ADDENDUM 3

ADDENDUM DATE: May 8th, 2019

PROJECT: OCSC Expansion - Phase 1, Seymour Center
2551 Homestead Rd.
Chapel Hill, NC 27516

Addendum #3

SHEET #
DSK-05

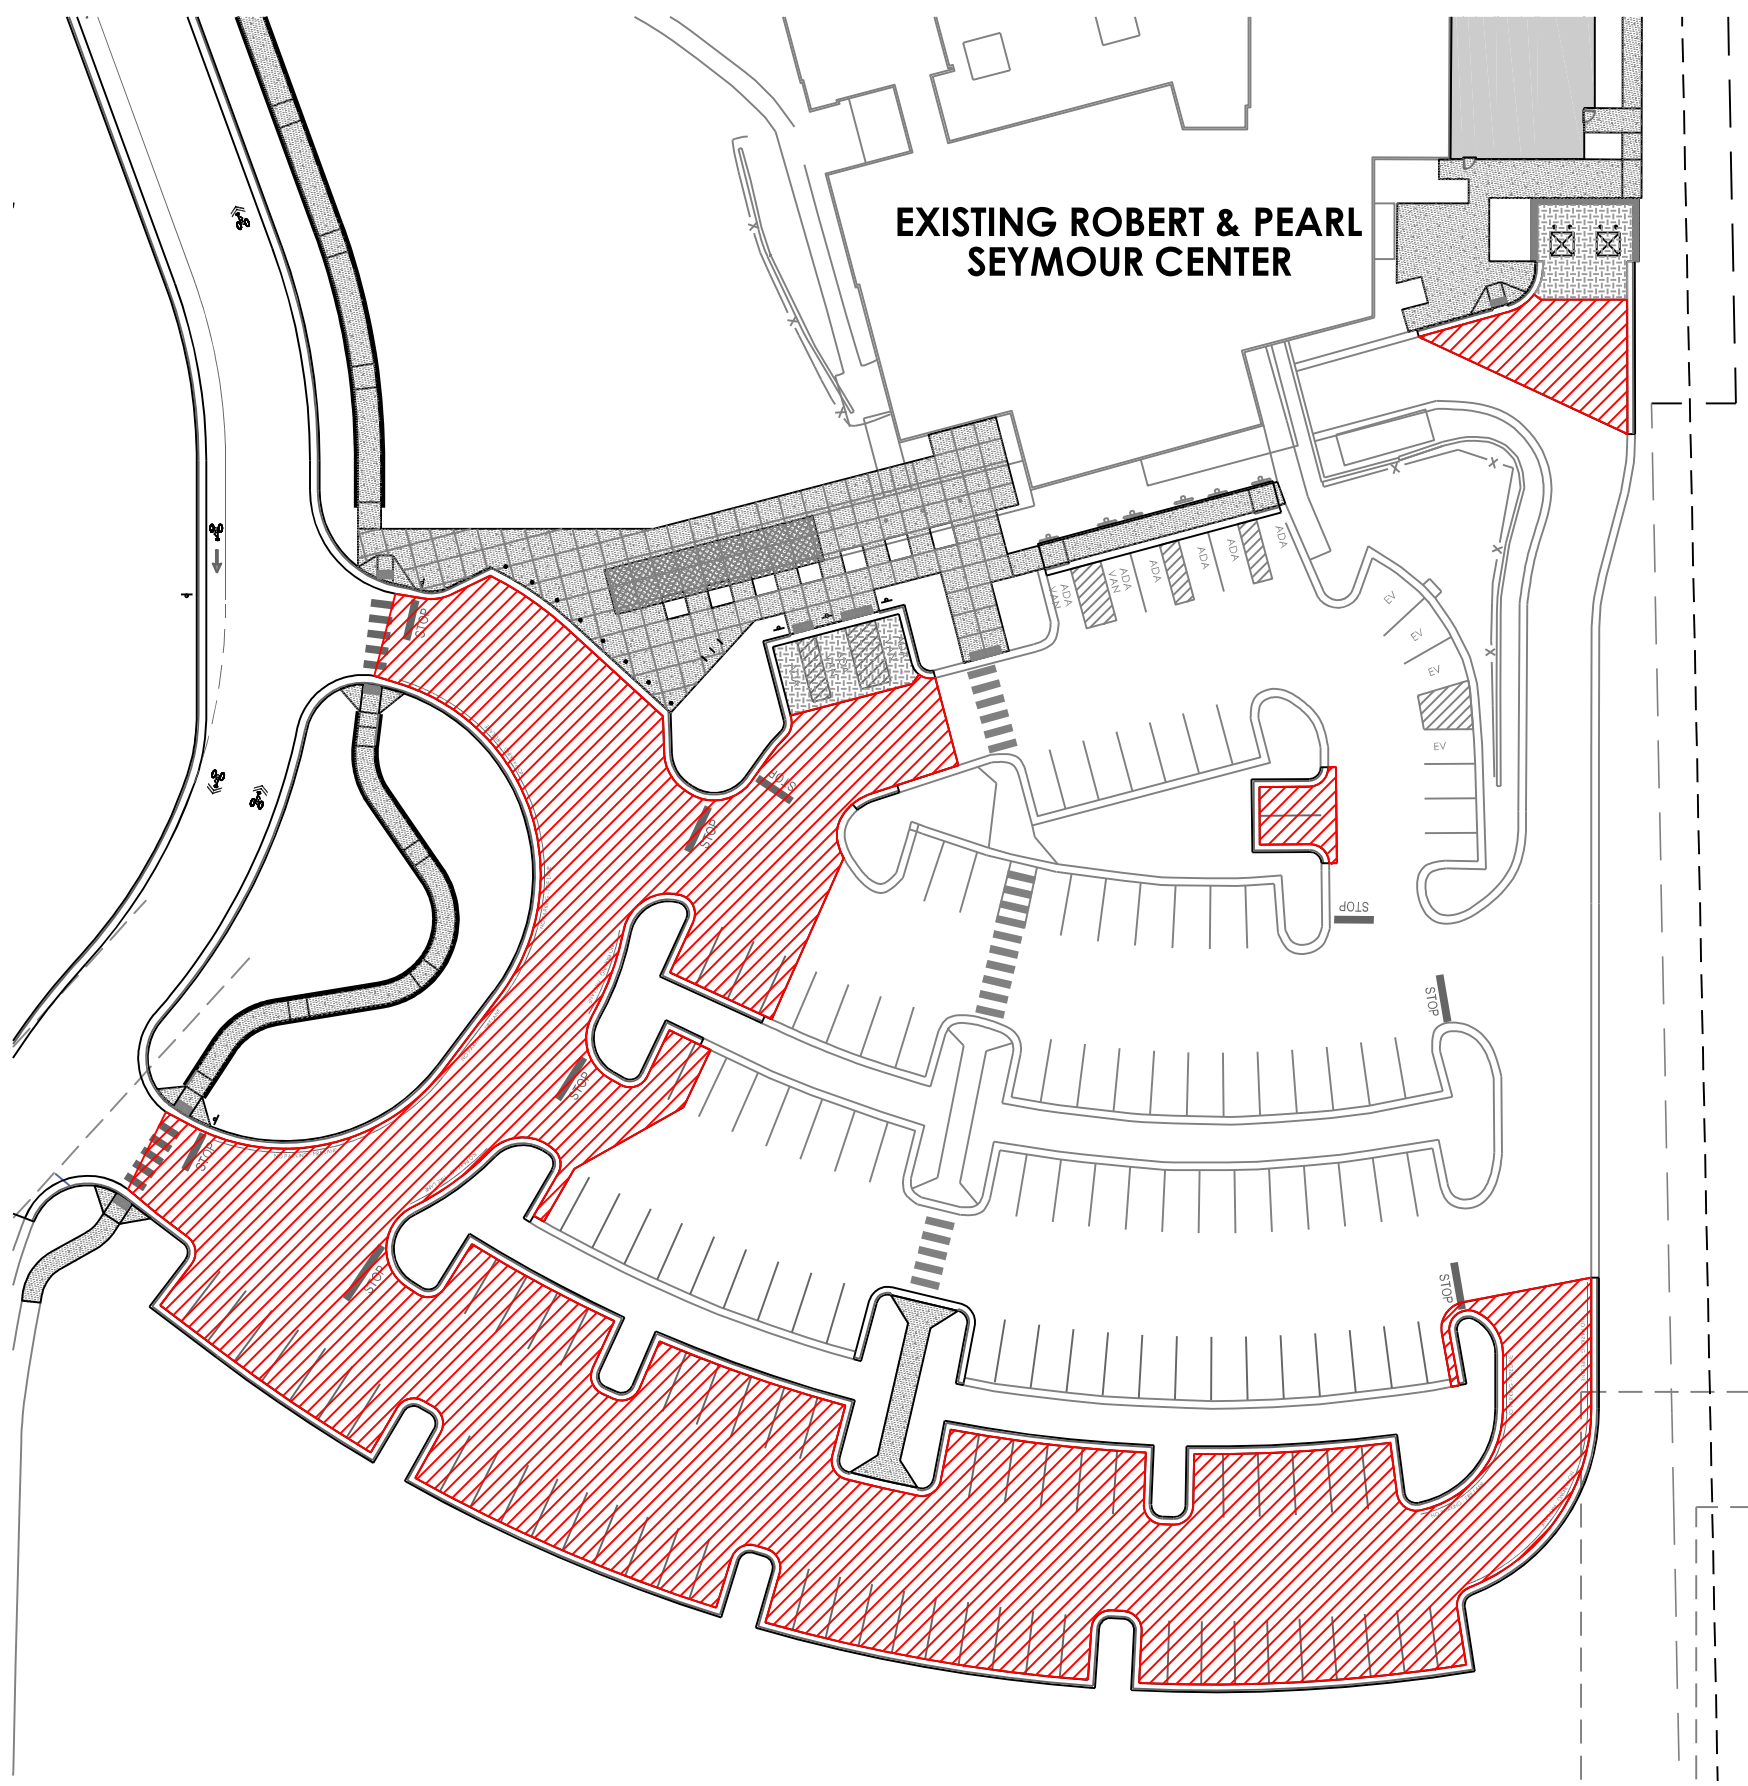
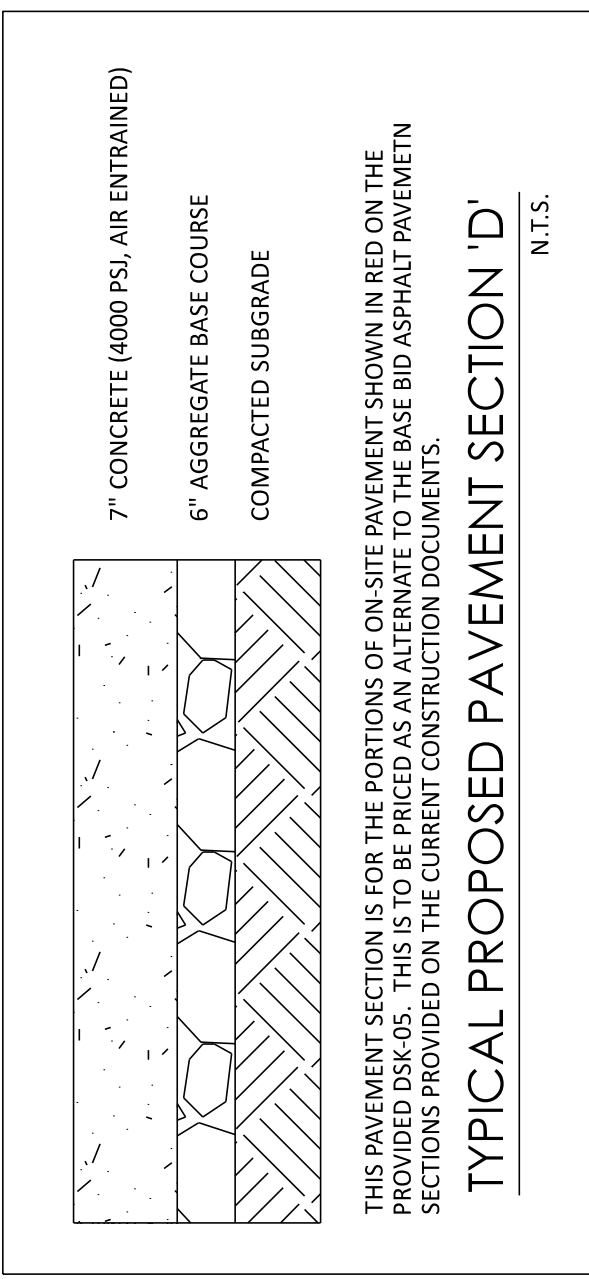
THIS PAVEMENT SECTION IS FOR THE PORTIONS OF ON-SITE PAVEMENT SHOWN IN RED ON THE PROVIDED DSK-05. THIS IS TO BE PRICED AS AN ALTERNATE TO THE BASE BID ASPHALT PAVEMENTN SECTIONS PROVIDED ON THE CURRENT CONSTRUCTION DOCUMENTS.
